BAYERISCHE MOTOREN WERKE
AKTIENGESELLSCHAFT

Circular-Letter of the Service Department
Motorcycles: Carburettor Group No. 1e/53

Subject: R 25/2 SAWE carburettor

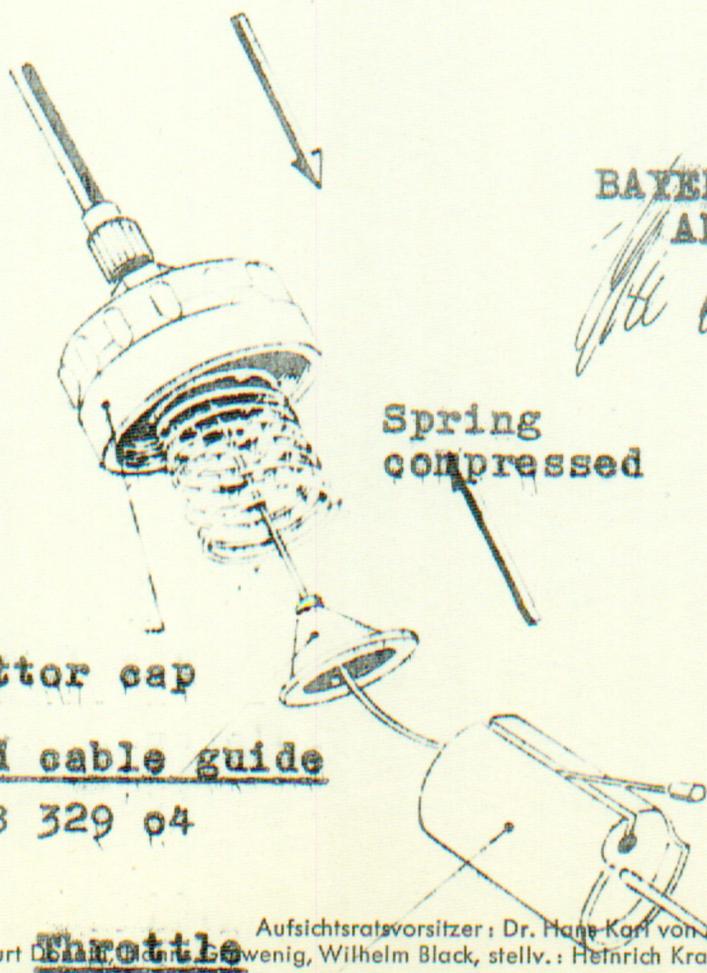
In order to prevent the throttle from being jammed due to a diagonal action of the Bowden cable, we have developed a bevelled cable guide 224 3 08 329 04, which we recommend to fit in every SAWE carburettor on already supplied machines. As per the figure inserted hereunder, this cable guide is pushed upon the cable and inserted between spring and throttle top end, so that it centralizes the cable.
